**CHESAPEAKE BAY TMDL PROJECT
(4 PONDS)
IFB No. 15304-FY17-15
Addendum #1
October 25, 2016**

UNIT RATE TABLE
Revised by Addendum No. 1

DESIGN BY: MB/TWJ DRAWN BY: TWJ
REVIEWED BY: MB/JGR
PROJECT MANAGER: TB
AMEC FOSTER WHEELER PROJECT #: 565500010
CONTRACT #: 300810-FY12-03
DATE: 2015-07-23 SHEET SIZE: D
SCALE: AS SHOWN
SHEET TITLE: EX. CONDITIONS AND DEMOLITION PLAN
SHEET 04 OF 28

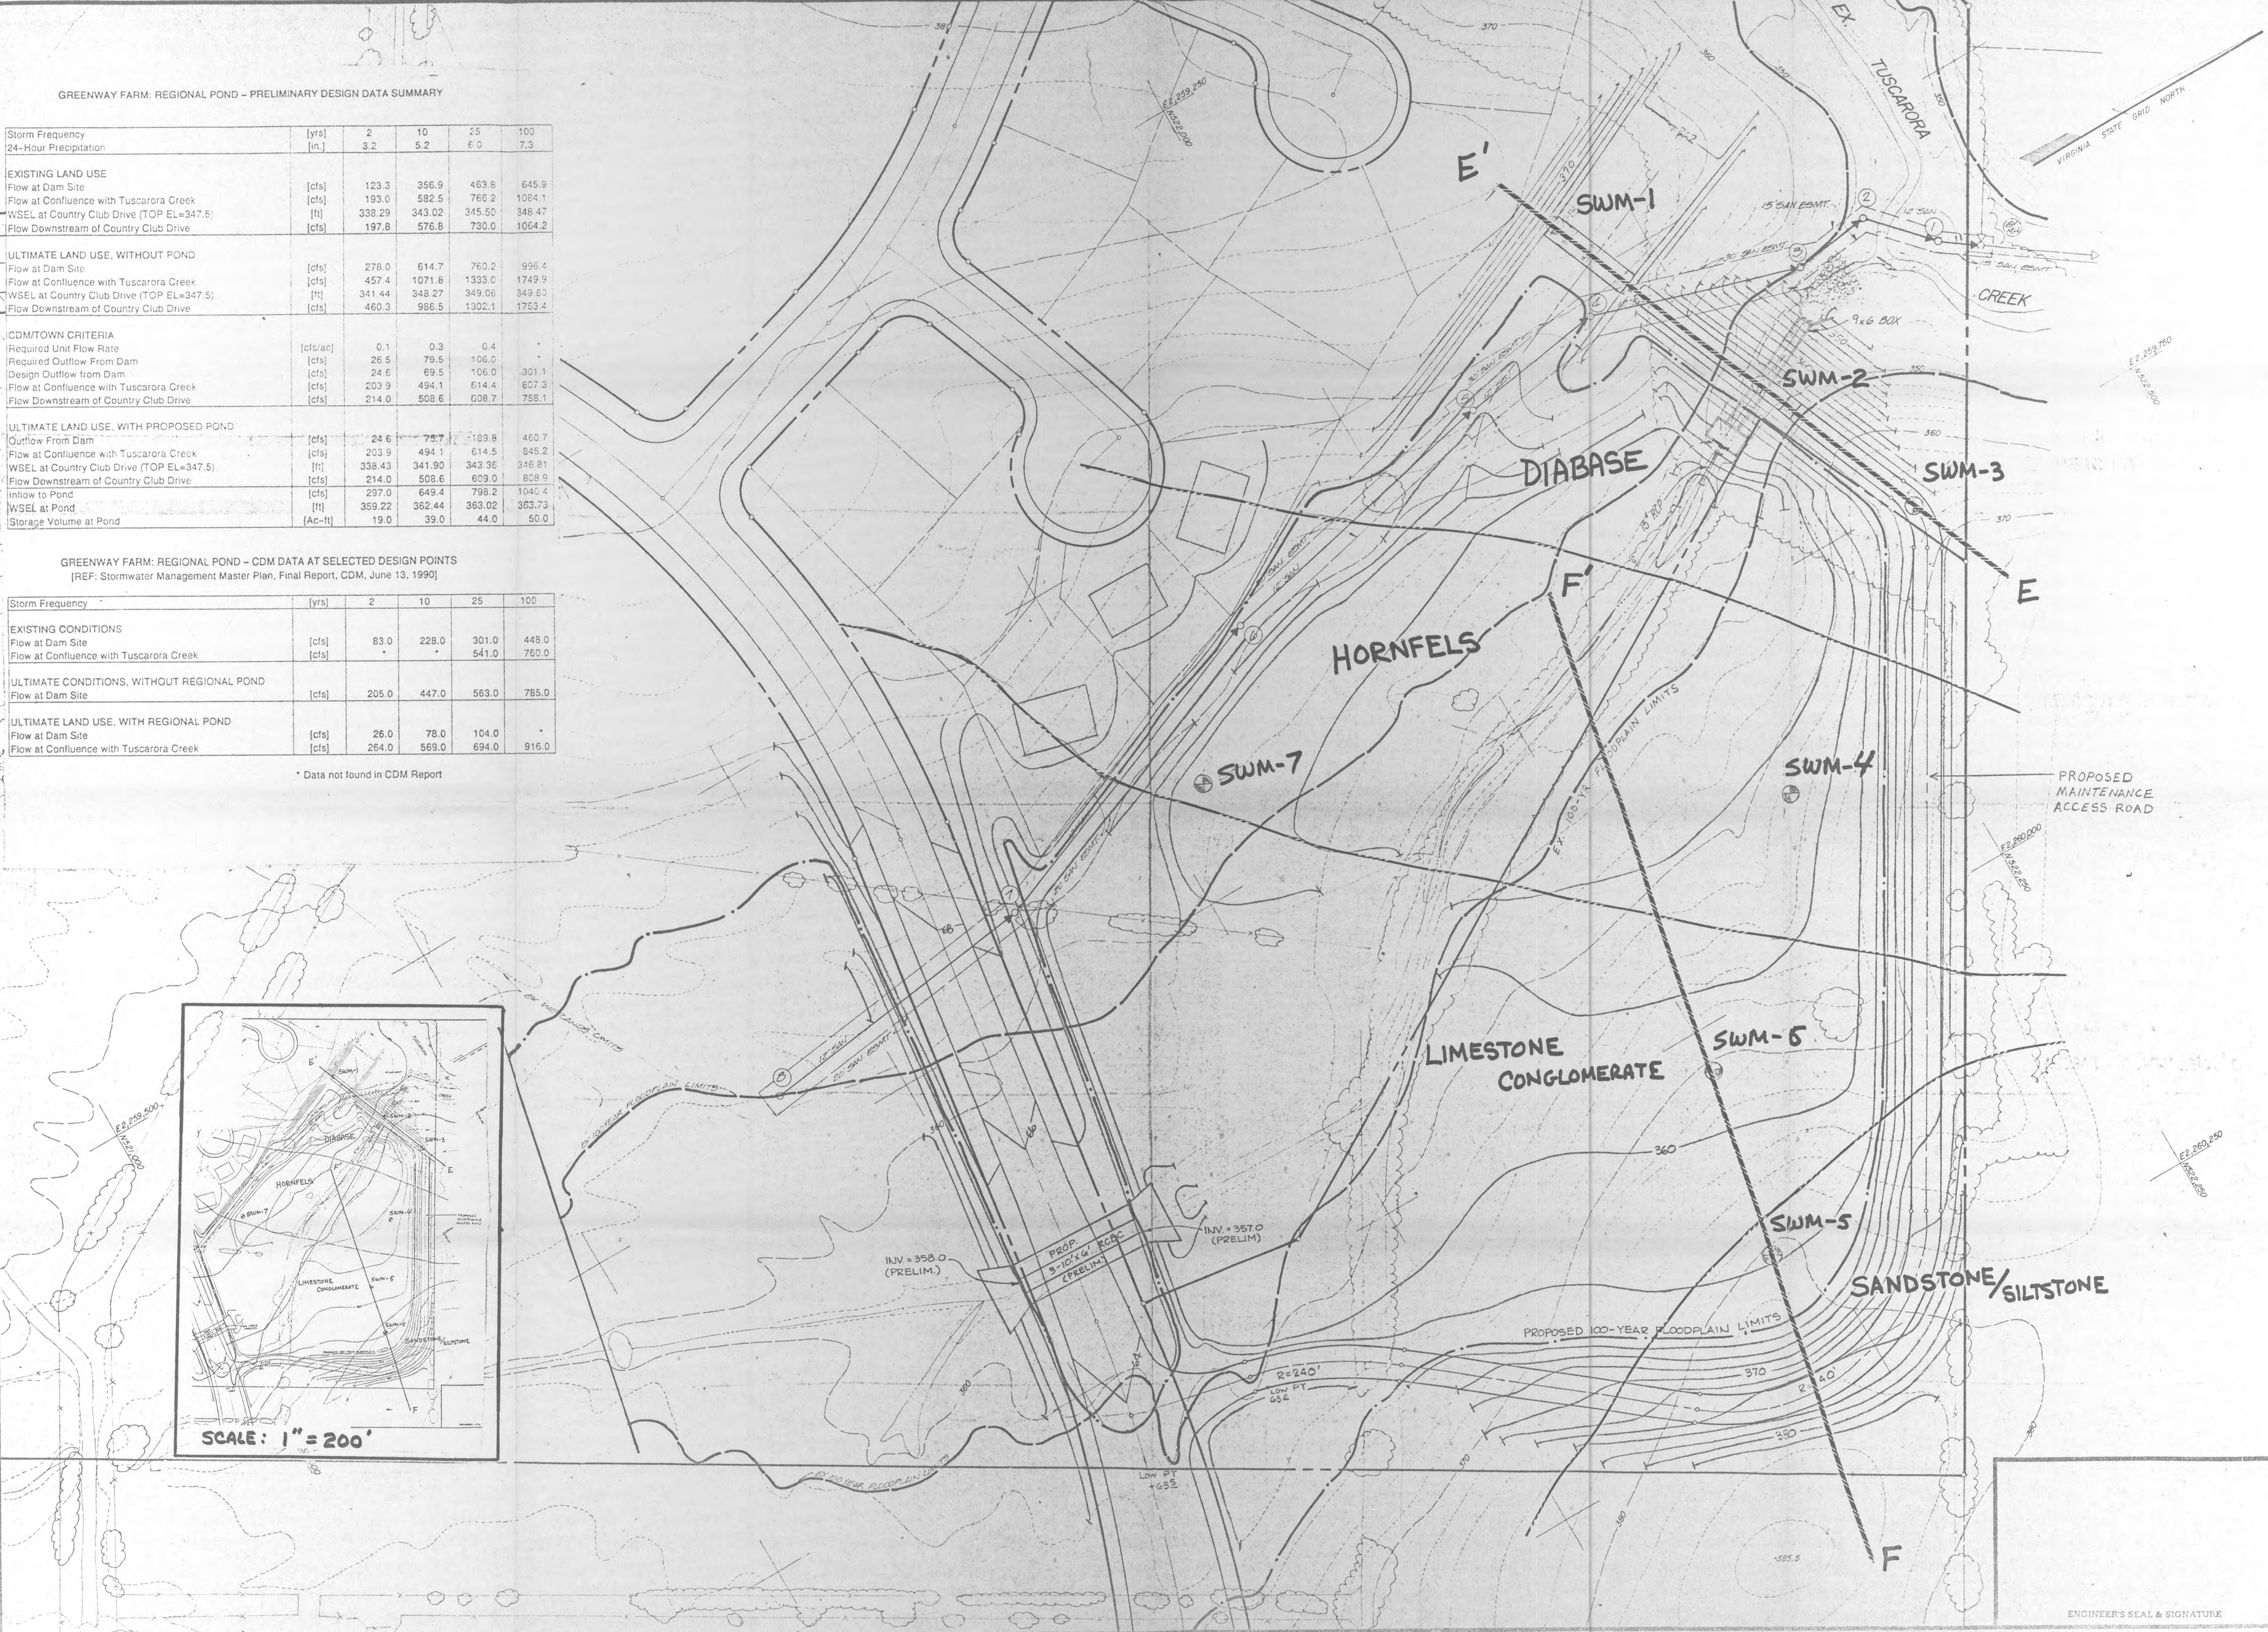
Question 4: Please Confirm that all clearing & grubbing is to be done by others and is not in the base bid?

Answer 4: All clearing and grubbing is part of this Contract. Kohl's Pond Sheet 6 and Greenway Farm Pond Sheet 4 have been revised (see Attachment 'B') to delete the "Clearing by Others" note. Wood chips from the cleared trees may be spread on the field on the east side of the stream in the Greenway Farm Pond area to a depth of no more than four inches.

Revised 10/14/16 to remove "Clearing by Others"
